Date of Application: 4/19/2023

SUBJECT: Preliminary Site Plan and Design review for 40 Residential Units 2306 Fillmore Street.

PROPOSED 39 UNITS
MULTI-FAMILY
DEVELOPMENT FOR:
2306 FILLMORE STREET
HOLLYWOOD FL

SHEET NO. A-202

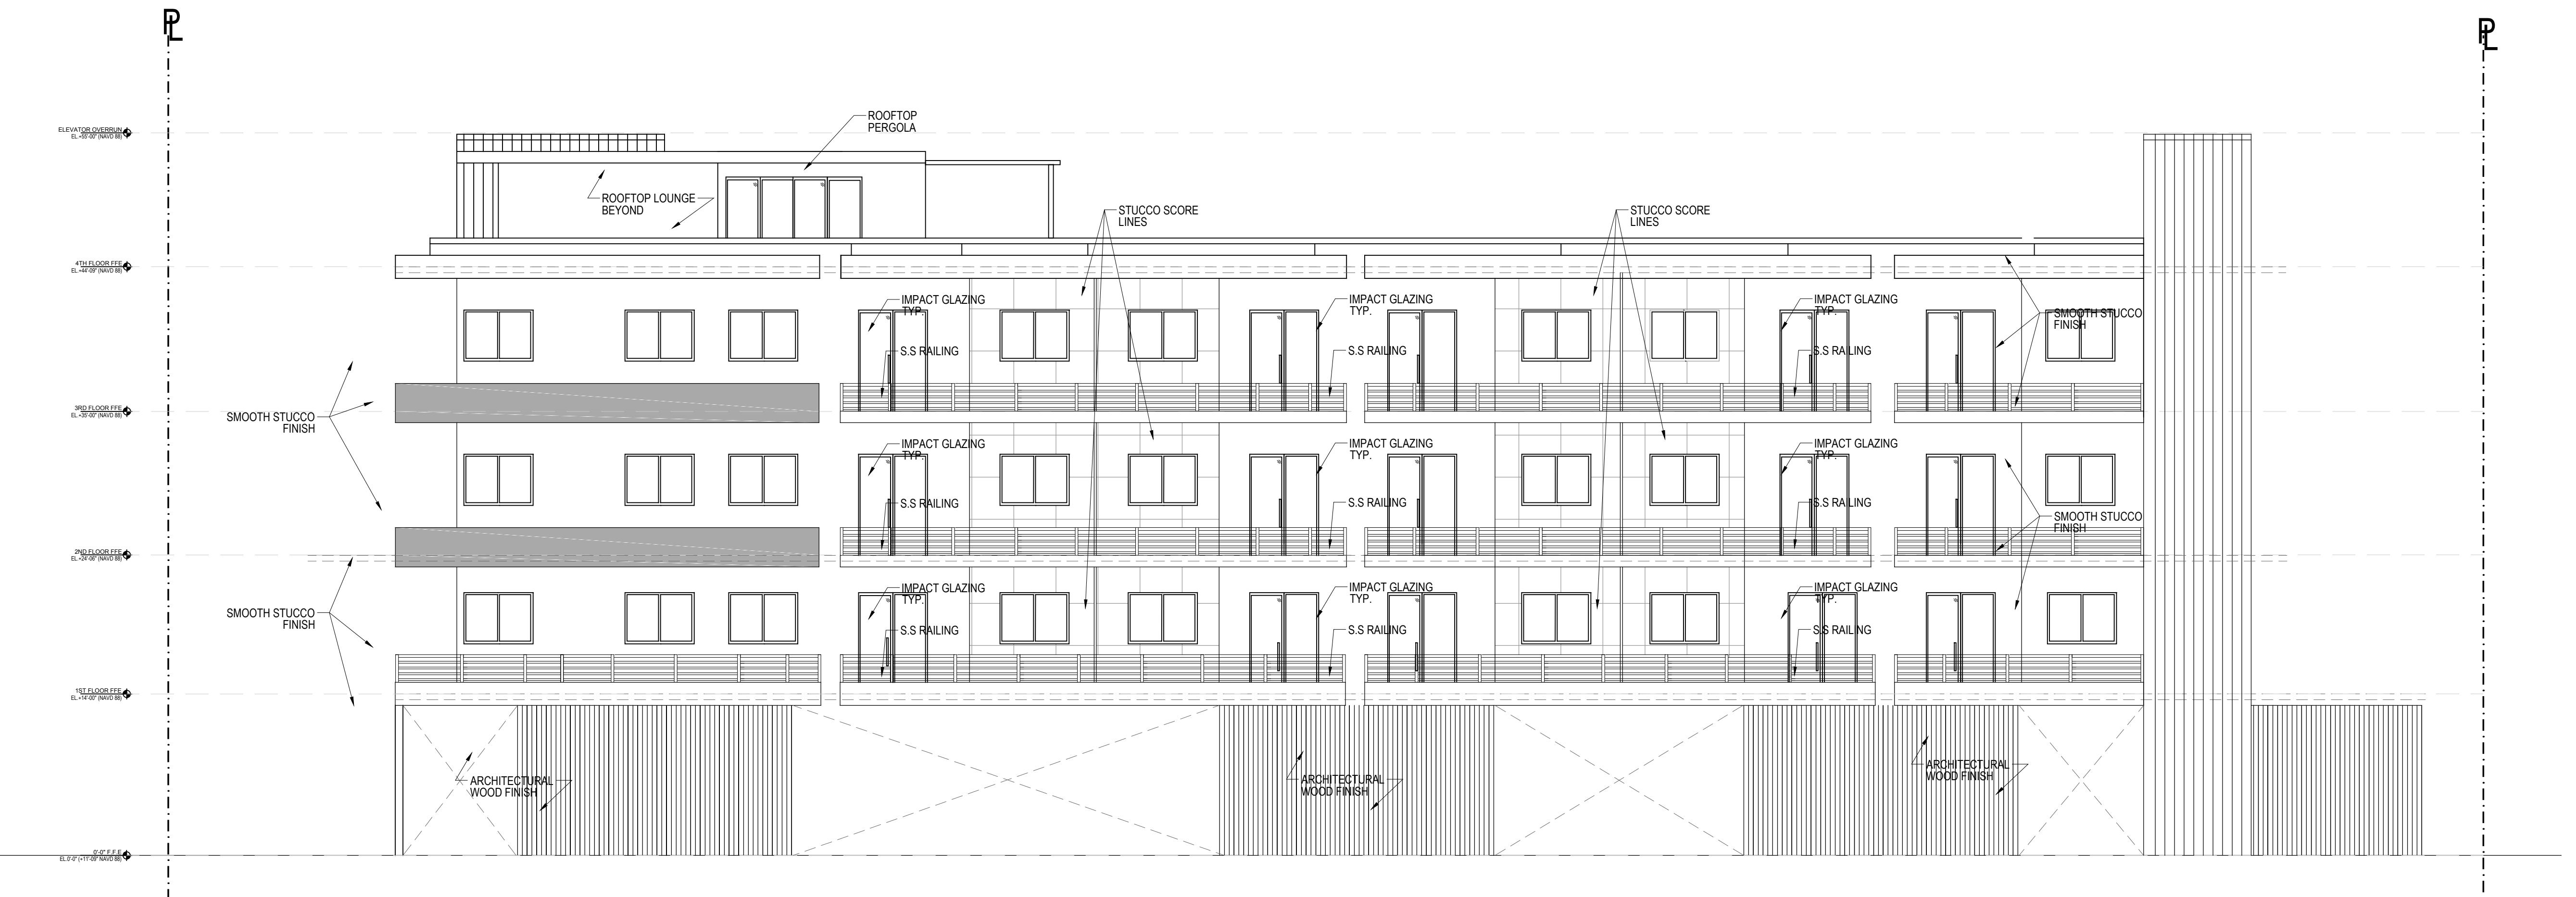
12. Please identify the vertical height clearance of the garage throughout and especially at the entrance and exit. Provide dimension on the elevation as well.

Response: Please see A-201 and A-202. Garage floor clearance is 14' and garage door clearance is 10'

01 DUMPSTER ENCLOSURE DTL
SCALE: 1/4"=1'-0"

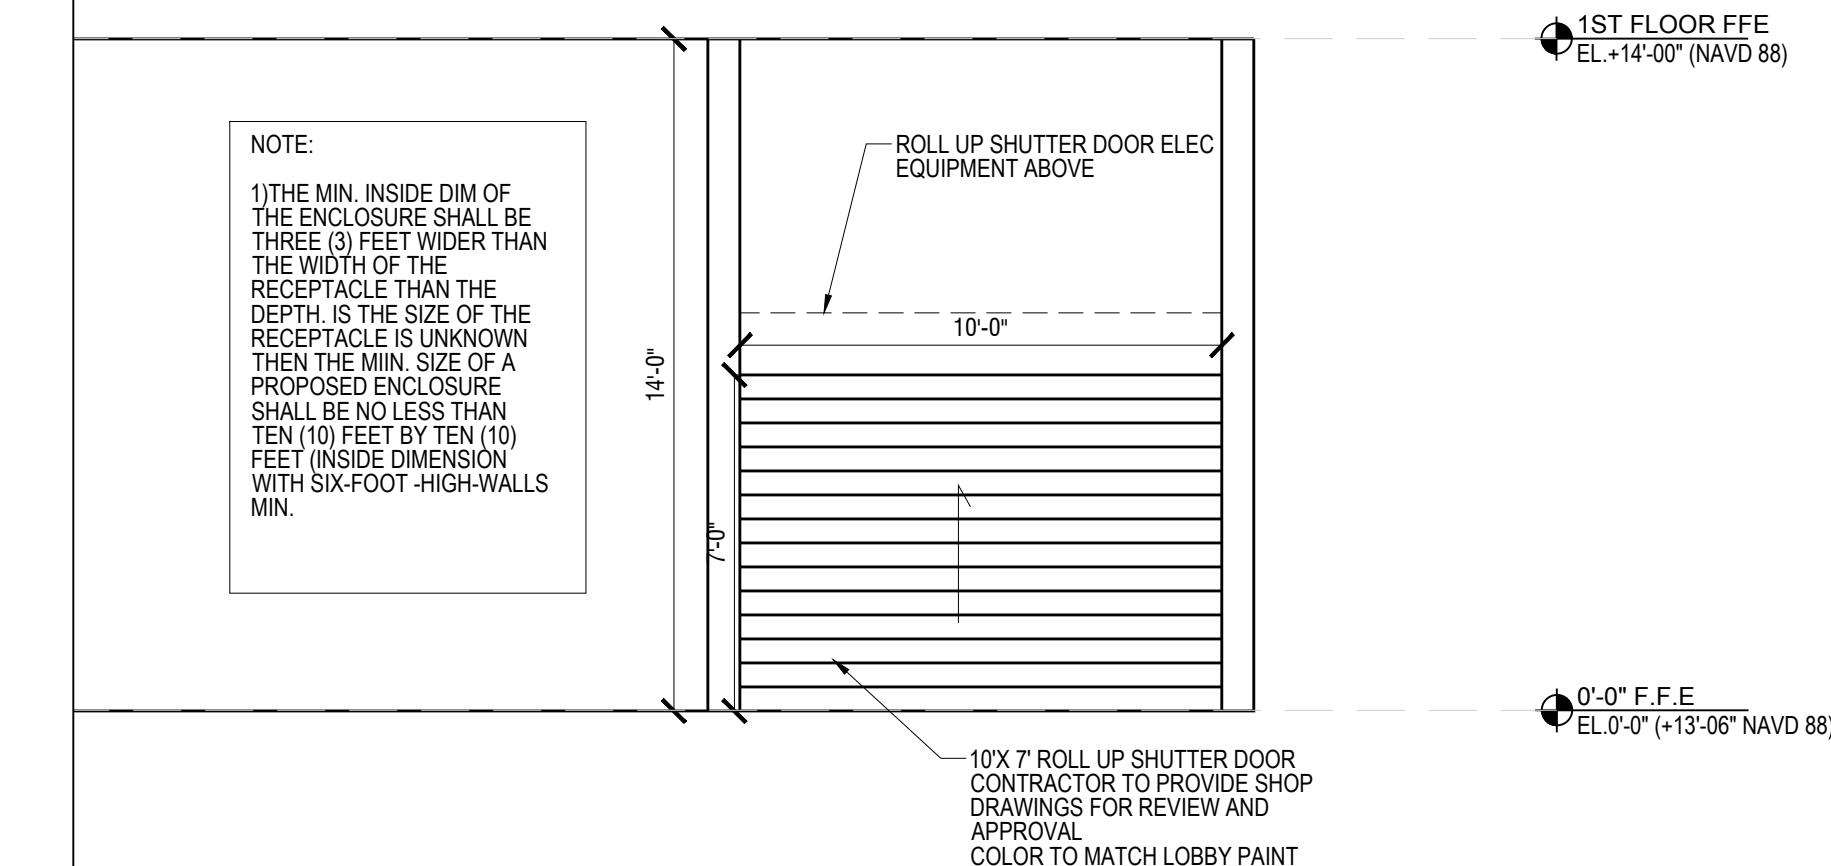
2. Dumpster enclosure required. Show dimensioned enclosure on site plan.

Response: Please see A-101 noting dimensions of trash enclosure. Also please see A-501 noting a detail of the dumpster enclosure.

DRAWING TITLE:
 TRUCK ROUTING
 ANALYSIS

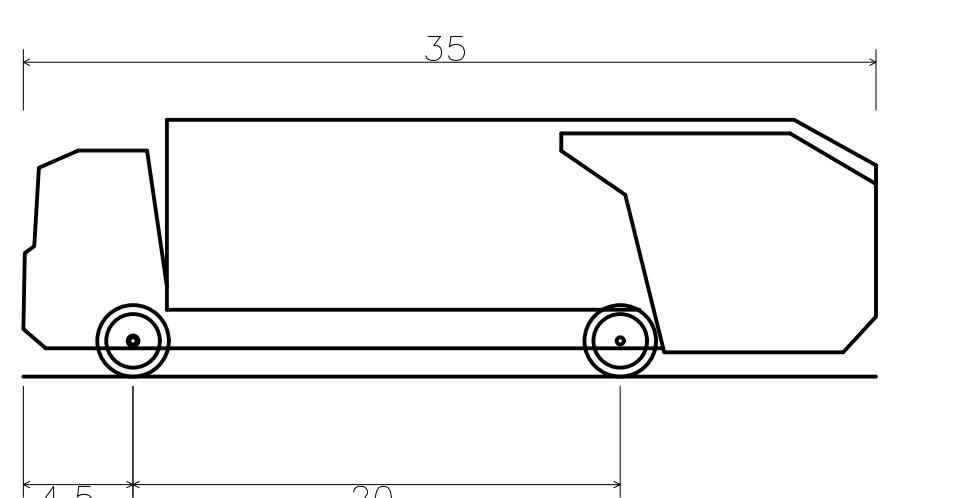
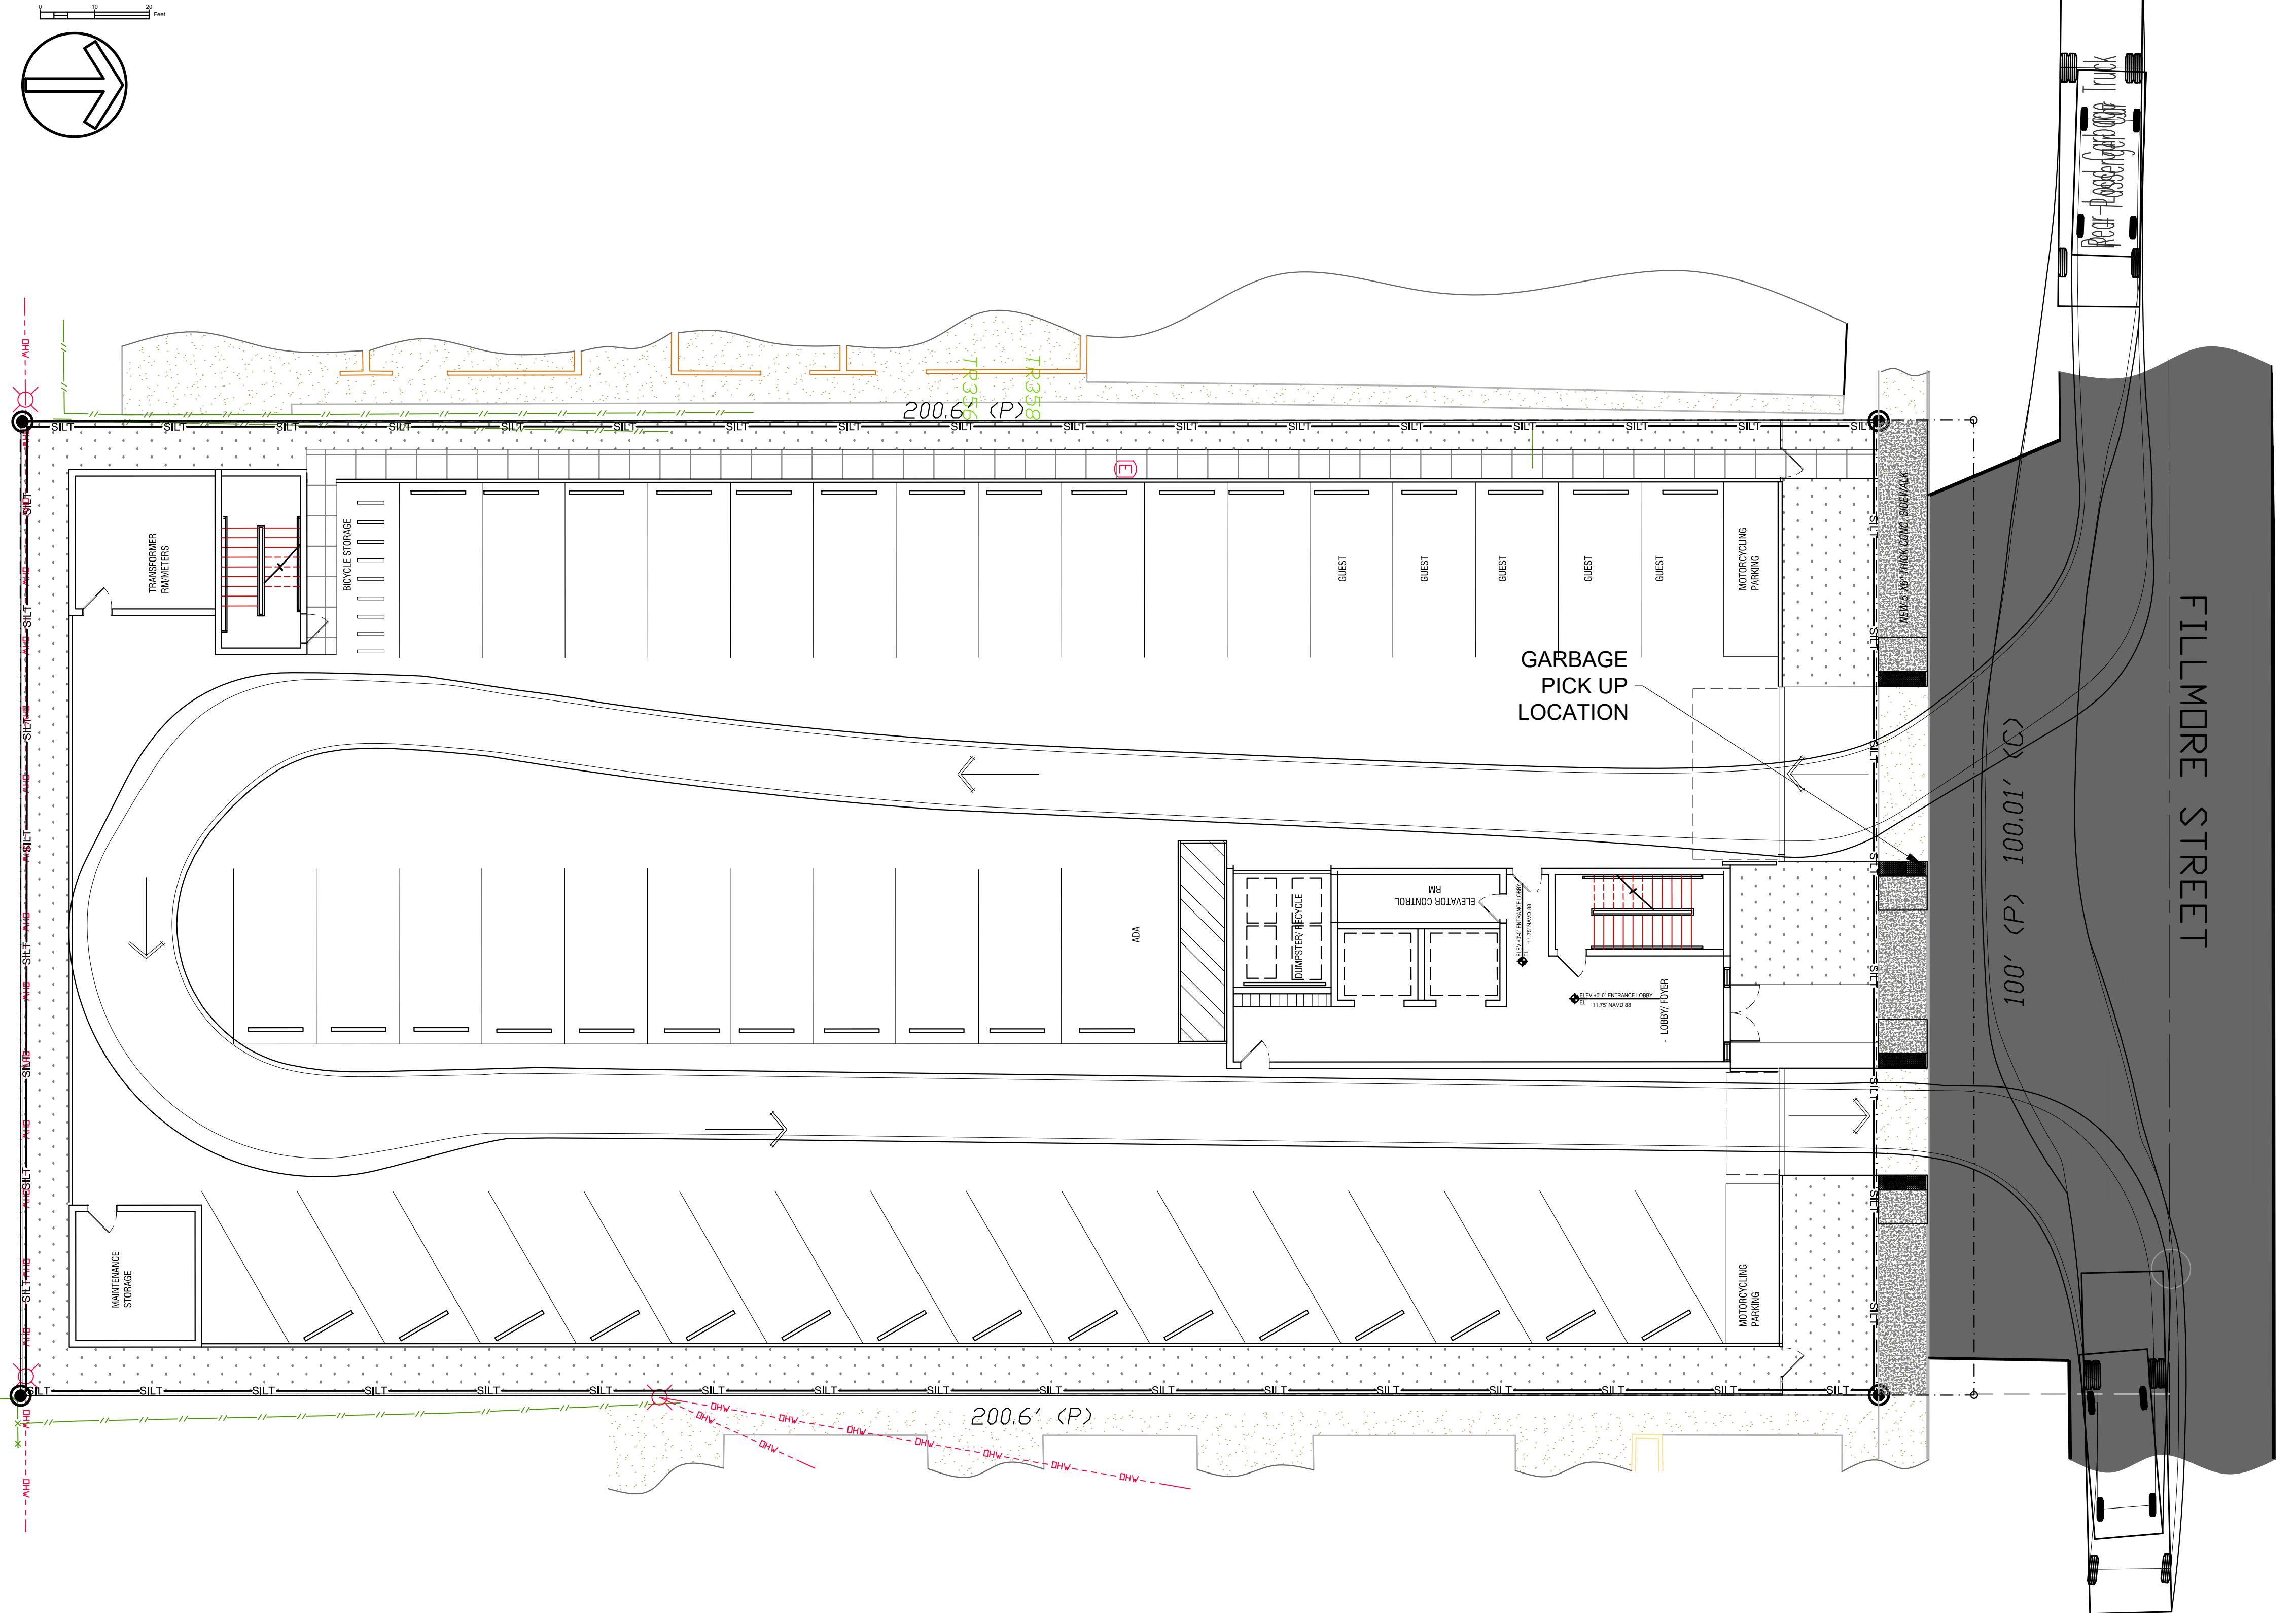
24. Provide AutoTurn analysis to show how trash trucks maneuverability through the site for pick up can be achieved. Be sure to have sufficient vertical clearance for dump truck operation to empty out dumpsters.

Response:Truck Routing Analysis (Autoturn) has been provided. Refer to sheet C-100. Dumpsters will be rolled out onto the street for pick up. Trucks are not expected to enter the parking garage.
